# Worldsid Update

# Agenda

# REASONS FOR BUILD LEVEL CHANGE FOR WORLDSID- 50<sup>TH</sup>

# SMALL FEMALE PELVIS CLEARANCE

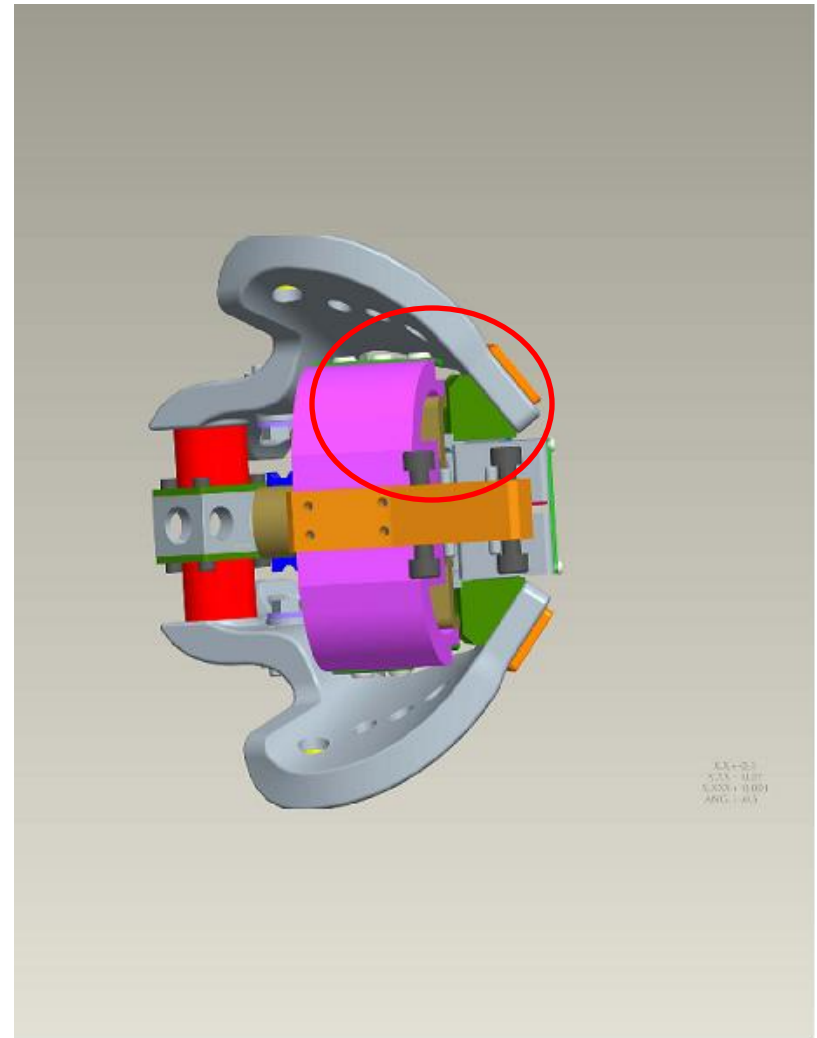
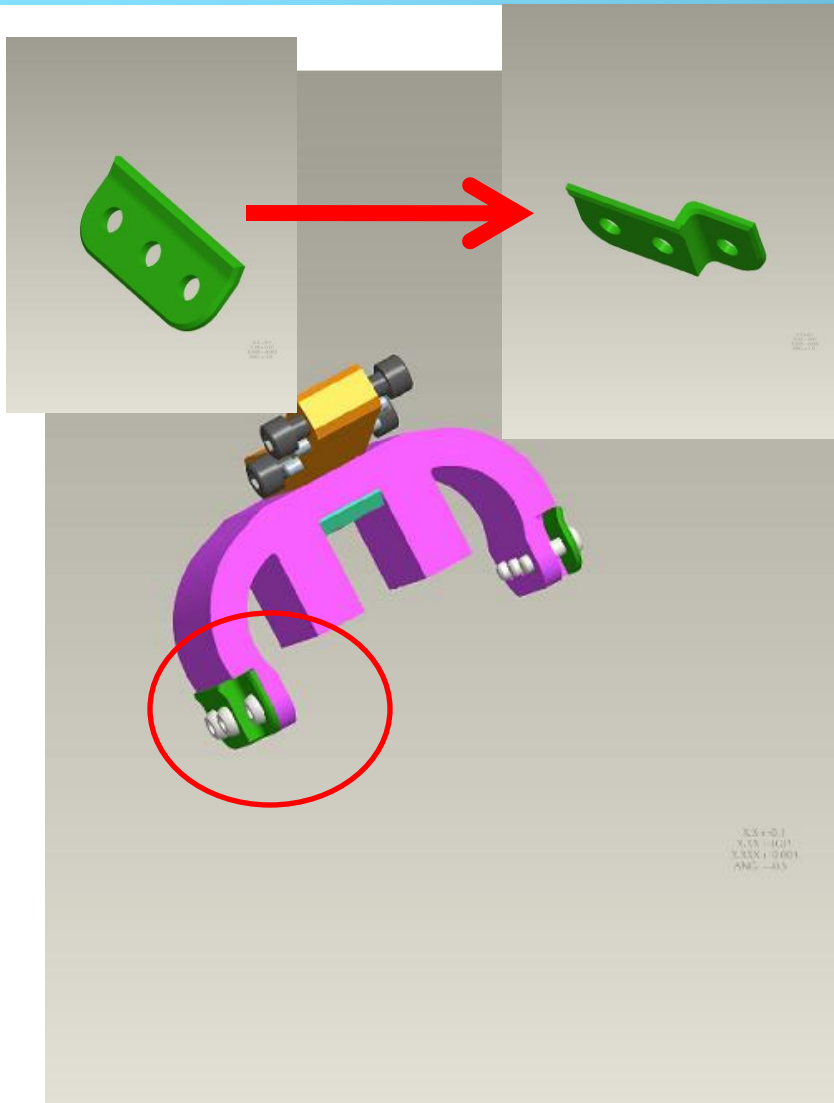
# Increase Clearance in the Front

# Increase Clearance at Lumbar

# Abdomen Rib/Pelvis Interaction

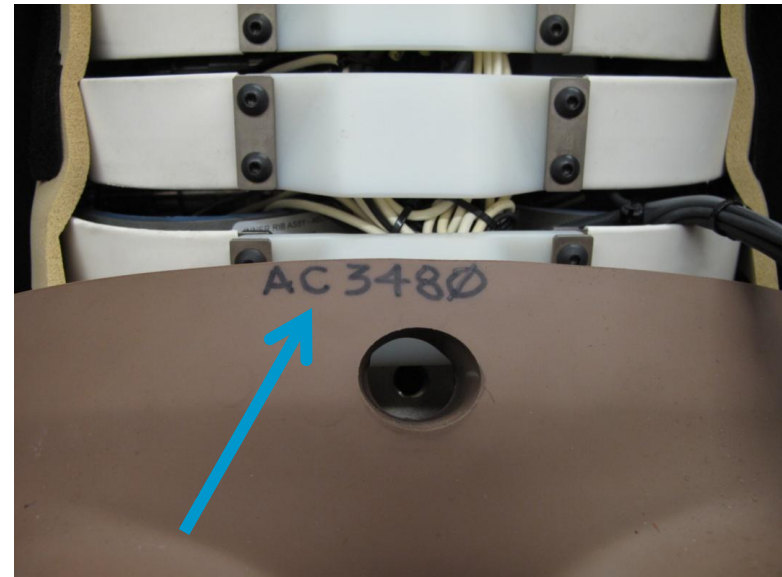
▶ 50<sup>th</sup>

▶ Need more tests

▶ 5<sup>th</sup>

- ▶ TRL found that there is some difference between rib deflections depending on rib location prior to test
- ▶ TEG has recommended a mold change

# W50-54054 WorldSID 50<sup>th</sup> Original Ankle

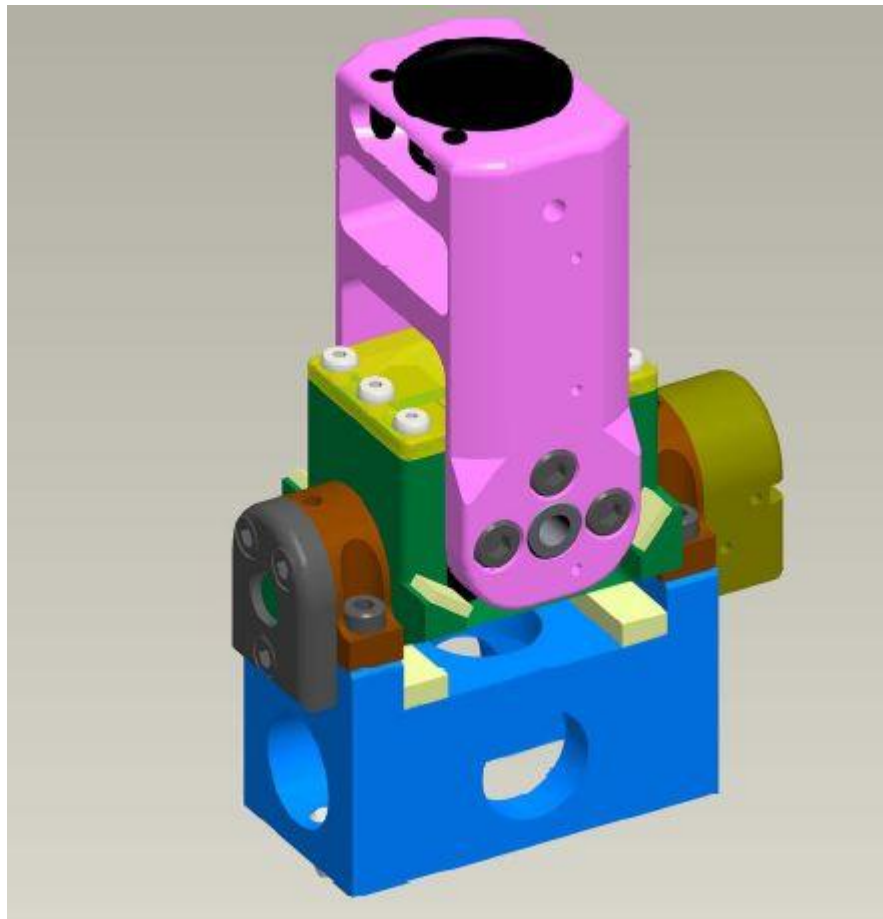
- ▶ Adapt WorldSID 5<sup>th</sup> ankle to WorldSID 50<sup>th</sup> dummy.
- ▶ Meet height and weight specifications of original 50<sup>th</sup> ankle.
- ▶ Maximize use of existing parts.

# W50-57000 WorldSID 50<sup>th</sup> Harmonized Ankle

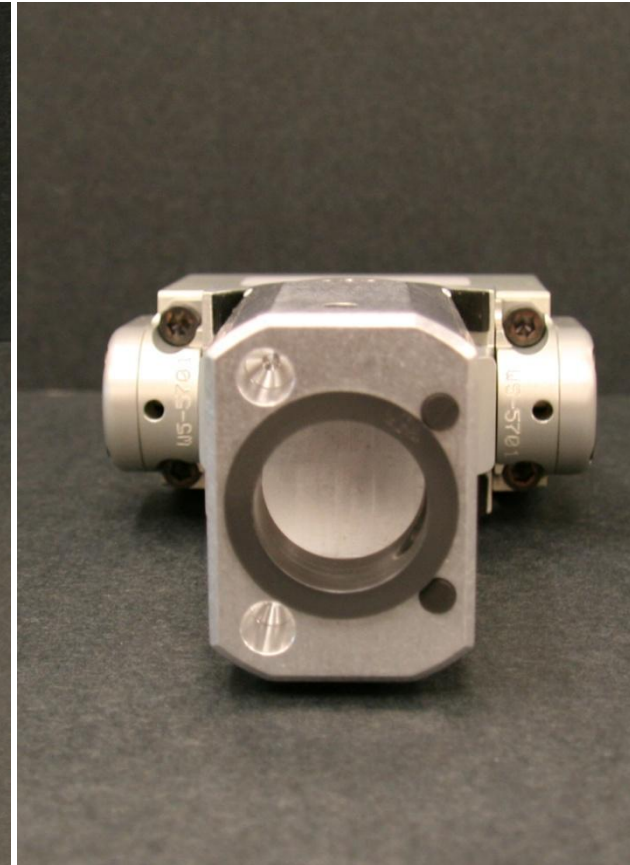
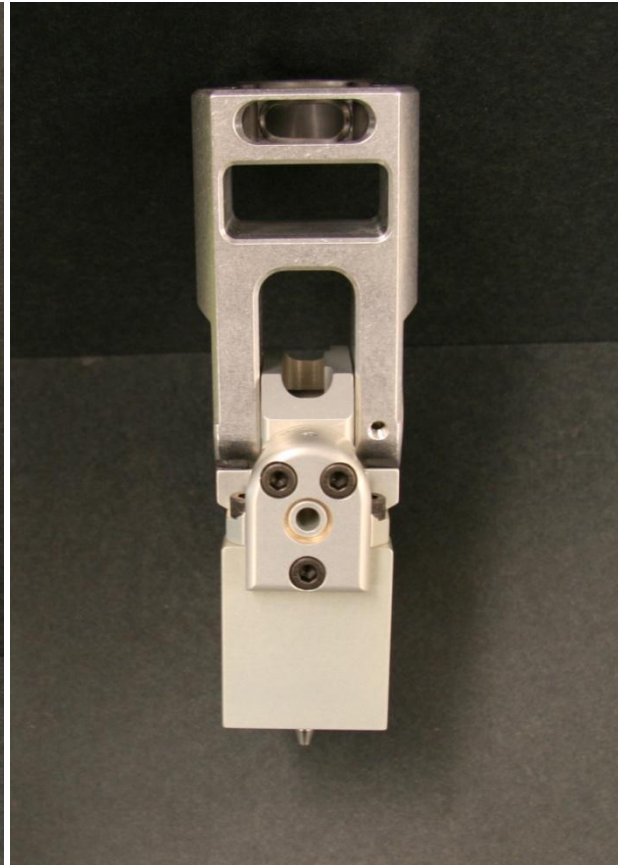
- Ankle is based on WorldSID 5<sup>th</sup> ankle design.
- Base block is modified from WorldSID 50<sup>th</sup> Ankle detail.
- Y-version upper clevis is lengthened and strengthened, based on WorldSID 5<sup>th</sup> Ankle detail.
- Weight and height match.
- WorldSID 5<sup>th</sup> ankle functionality is maintained.

# WorldSID-50<sup>th</sup> Jacket

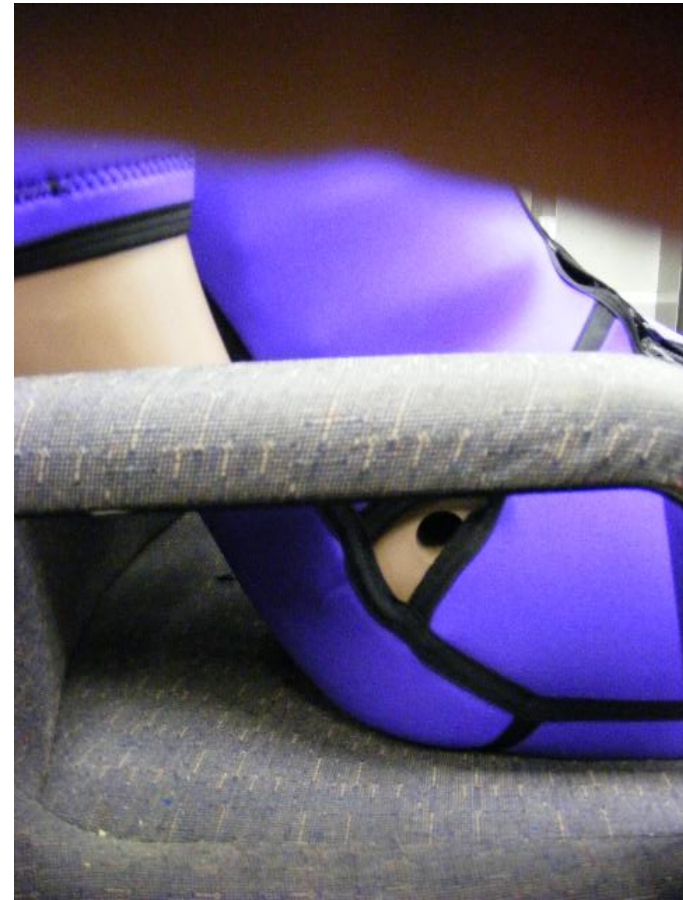
- H point holes
  - ▶ Relocate and finish with sewn border (COMPLETED)
- Shoulder bolt holes
  - ▶ Enlarge and finish with sewn border (COMPLETED)
- Arms
  - ▶ Remove and finish arm pit holes (TASK DELETED).
  - ▶ Removal of the jacket arms was requested after the project was started so first task was stopped. Removal of arm material was not completed due to timing. (TO BE COMPLETED ON NEXT PROTOTYPE BUILD)
- Humanetics logo
  - ▶ Move to front of jacket (TO BE COMPLETED ON NEXT PROTOTYPE BUILD)
- Knee holes
  - ▶ Re-align holes with center knee rotation (TO BE COMPLETED ON NEXT BUILD)

# Revise Current 2D pot with a more repeatable pot design

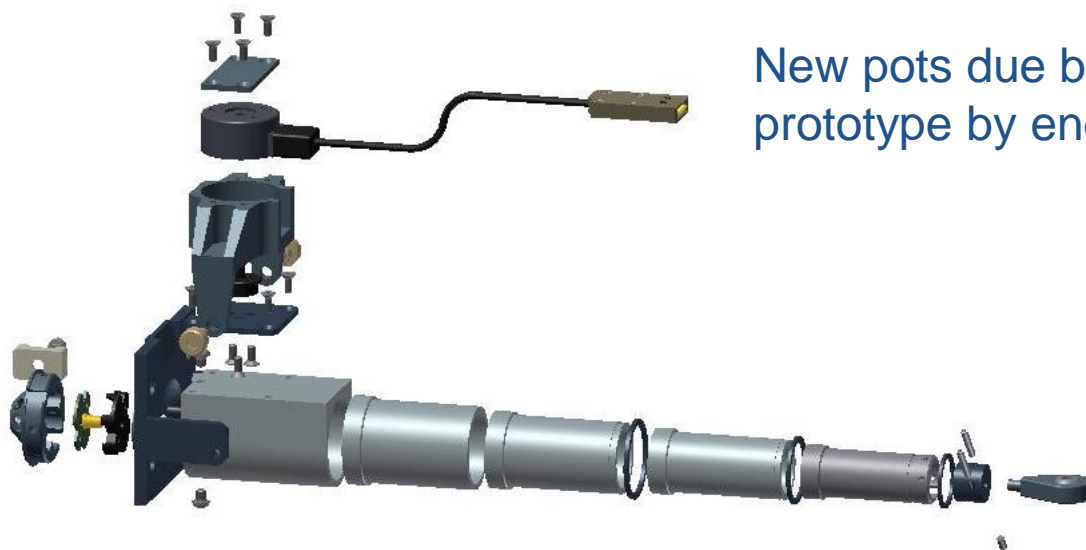
Spec issue with Rod End: current rod  
end has spec of 13°, can be changed to  
25°

New pots due by end of March, will have prototype by end of April

# WSID LIFT

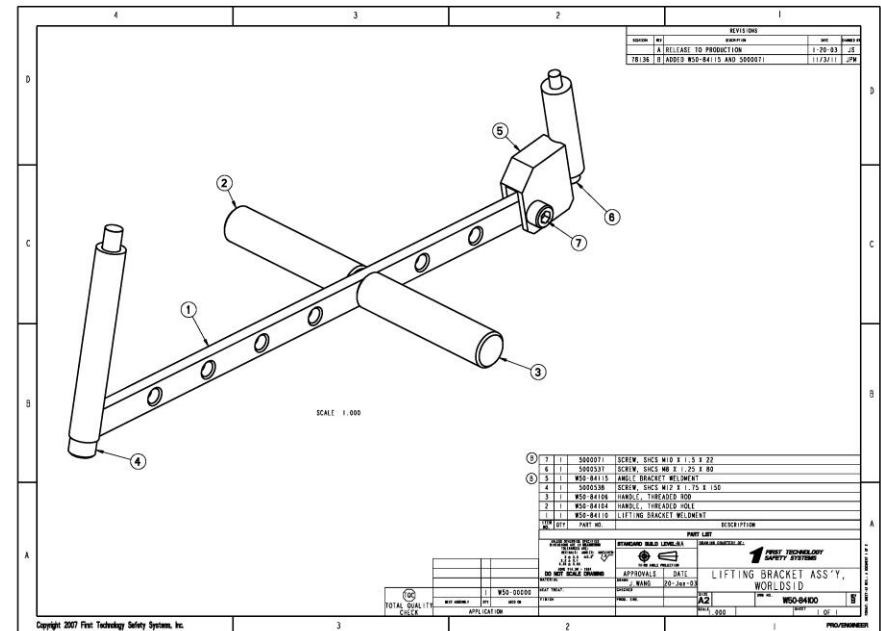
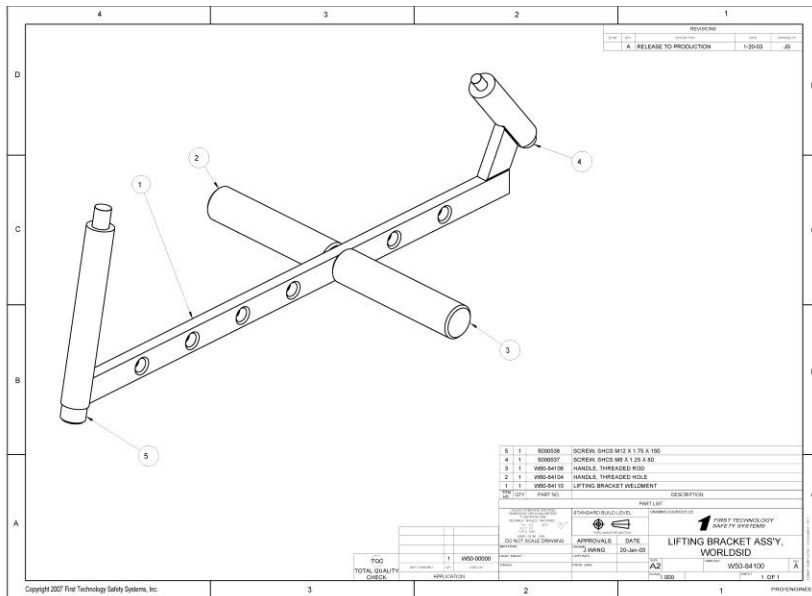
Original WSID lift:

1. Too difficult to align both screws at once

Revised WSID lift:

1. Split design allows for easier installation.

# WSID PUBIC MOLD

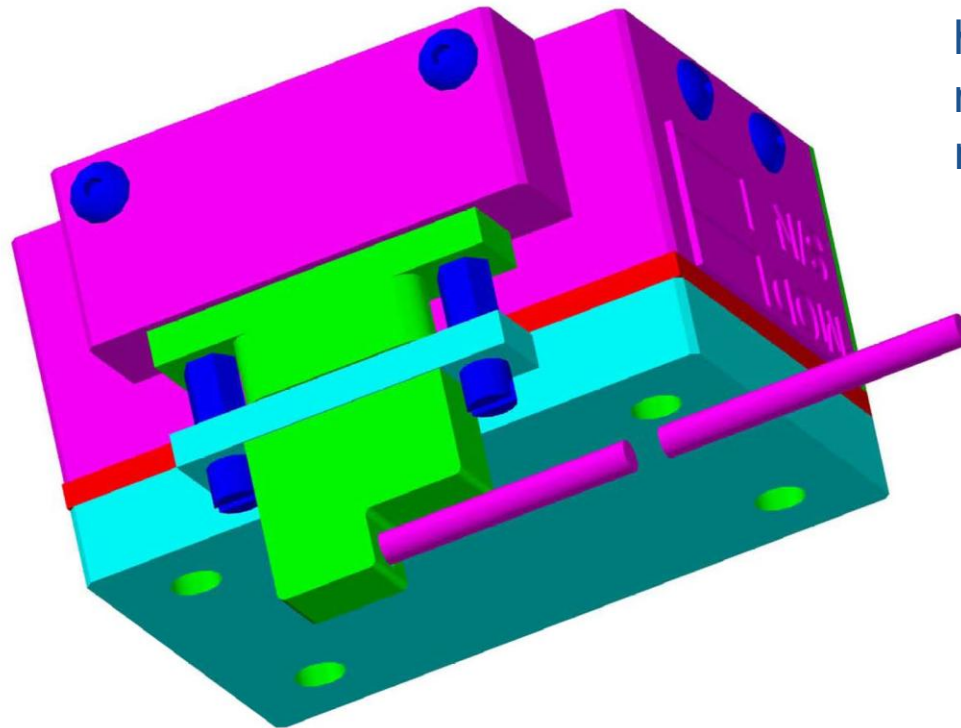
Connector location  
has been move and  
mold has been  
revised

# WorldSID Iliac Wing Material Change

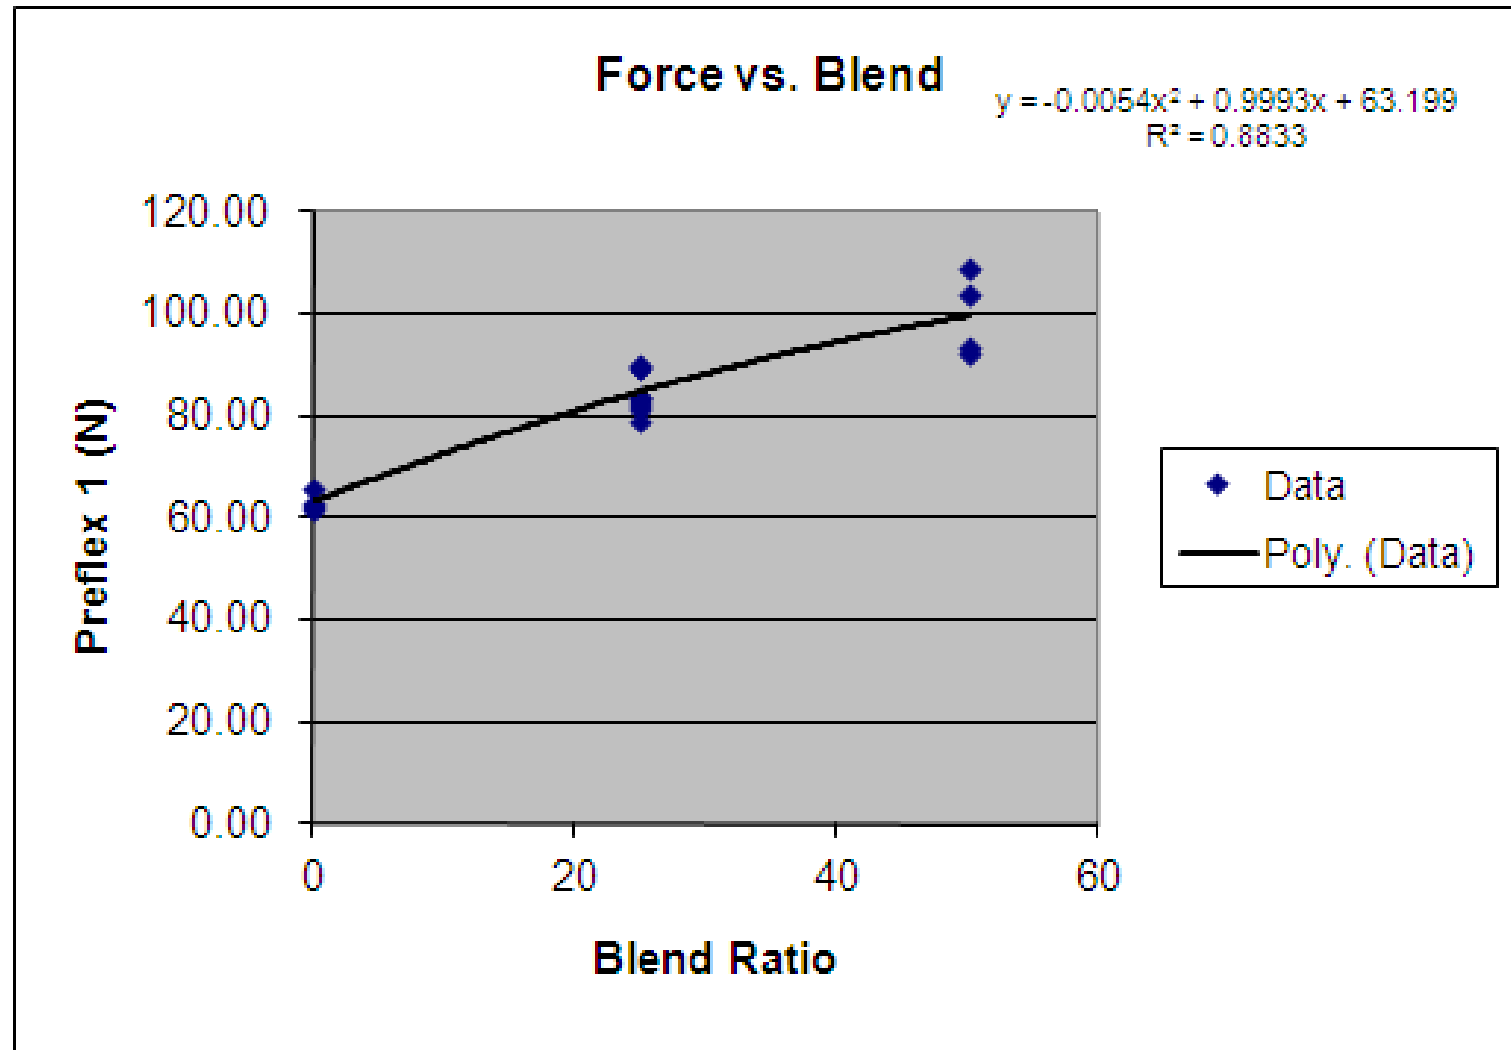
## ▶ Problem

- Ureol material no longer available
- Will run out in coming months

## ▶ Action plan

- Design & build new mold
- Develop equivalent material
  - ▶ Develop process with new material
  - ▶ Match Ureol at material sample level
  - ▶ Static & Dynamic component level tests
- Final verifications
  - ▶ Dummy certification tests
  - ▶ Dummy pendulum biofidelity tests
  - ▶ WorldSID task group trials

# WSID Skull Material Status

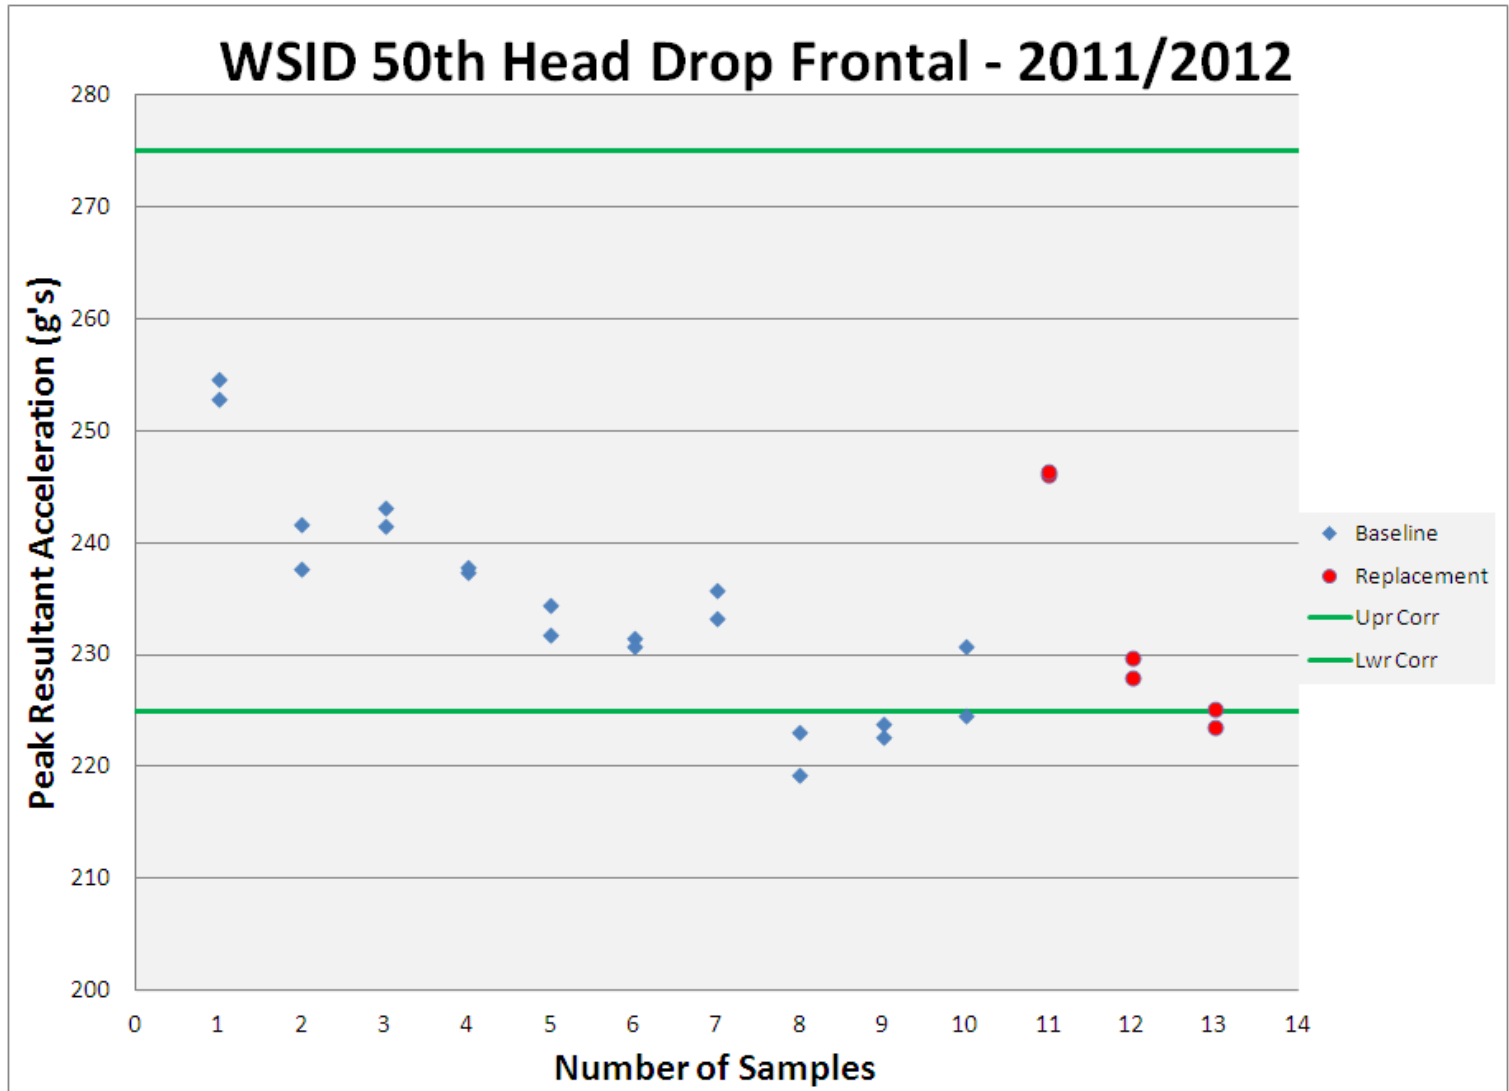
## ▶ Material Testing

- Evaluate polyurethane samples
  - ▶ Pour round pucks and test
- Make skulls from new material
  - ▶ Modal frequency evaluation to determine resonance
- Pour skull/skin combination and test
  - ▶ Head Drop Tests – Lateral and Frontal

## ▶ Status

- Material evaluations continue
- Review past performance of Ureol heads
